Attn: Mr. Yu. Ivanyan

Head of Department for Investigation
of Corruption-related Property Crimes and Cybercrimes,
RA Investigative Committee

Hereby please be informed that pursuant to the requirements defined by RA Criminal Procedure Code, **Lydian Armenia, CJSC** (hereinafter referred to as the **Company**) confirms it has recently been provided with what it has been informed is an Armenian translation of the final version of the complex audit expert opinion from ELARD, assigned under criminal case No. 69104118.

Figure 1: Flow Chart of Contact Water Conditions and Contingencies

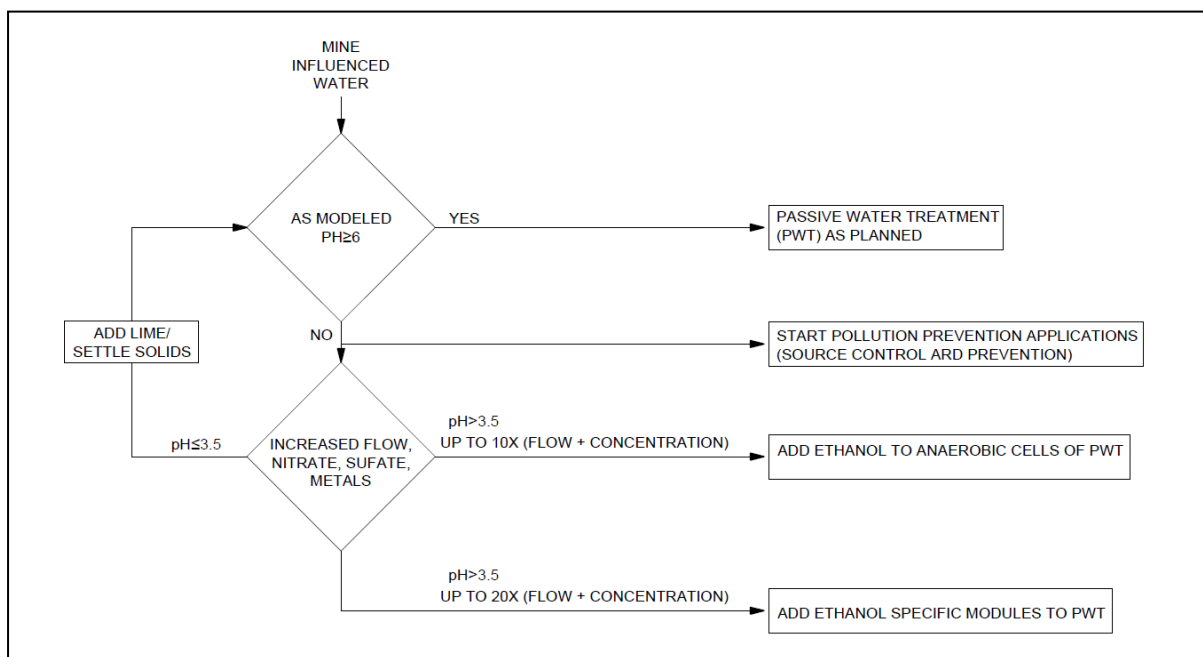
ELARD recommends contingency planning with regards to water treatment. The following flow chart shows the adaptations to the current management plan which could be implemented if the water conditions do not match our current predictions.

Figure 2: Process Flow Diagram for pH Pre-Conditioning

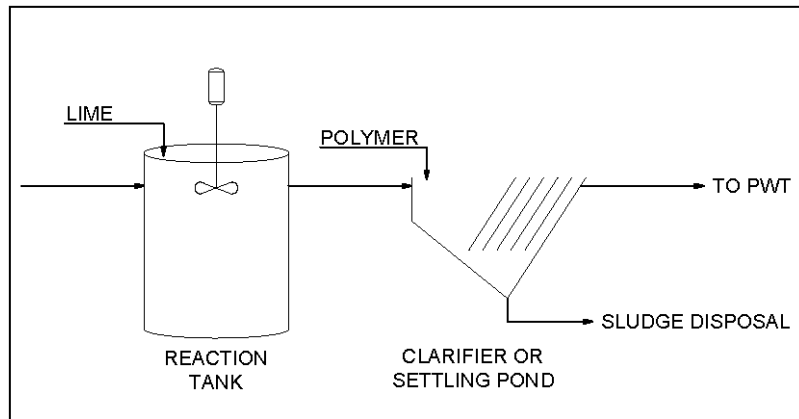
As a result of the planned ARD prevention measures, low pH is not anticipated; however, Lydian recognises that the pH of contact water could be below 3.5. If during operations or closure this becomes the case, the first response would be to employ ARD-suppression technology. ARD suppressants would be applied to the waste rock (BRSF and pit back fill) with the highest sulphide concentrations as defined by the ARD block model. The use of lime in pH mitigation was included in the ARD Management Plan.

The next response would be pre-conditioning of contact water with lime prior to passive treatment. This is an integration of the “active treatment” requested by ELARD. pH adjustment can be carried out using a commercially available lime dosing plant. This plant will comprise a lime storage, a reaction tank, and a clarifier (using polymer flocculant). Figure 2 shows the Process Flow Diagram for the pH adjustment plant.

Figure 3: PTS with Ethanol Feed and Additional Modules

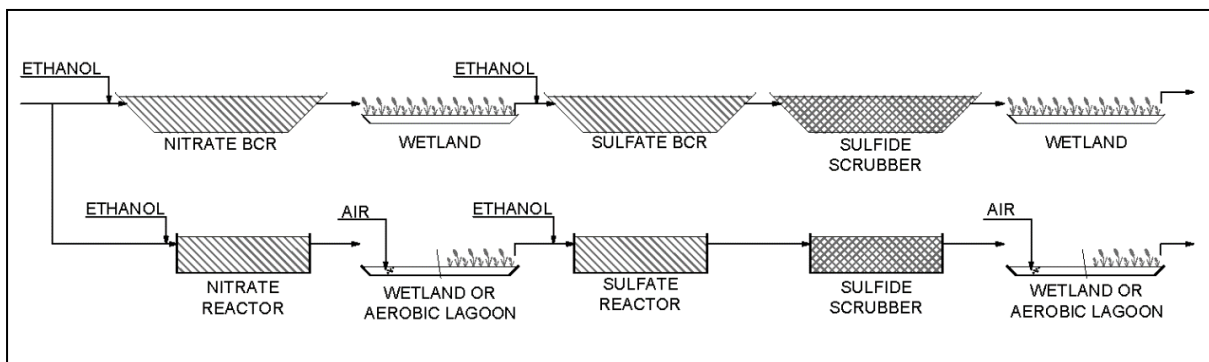
In the unlikely event that higher than predicted concentration of nitrates and/or sulphates are identified then the next treatment enhancement would be to dose the bioreactors with ethanol and/or air injection. This ethanol dosing increases the potency of the bioreactor and augments the rate of nitrate or sulphate reduction. Air injection augments the effectiveness of aerobic-driven processes within the PTS. This allows for greater throughput and shorter residence time. Figure 3 shows the Process Flow Diagram for the ethanol-augmented bioreactors.
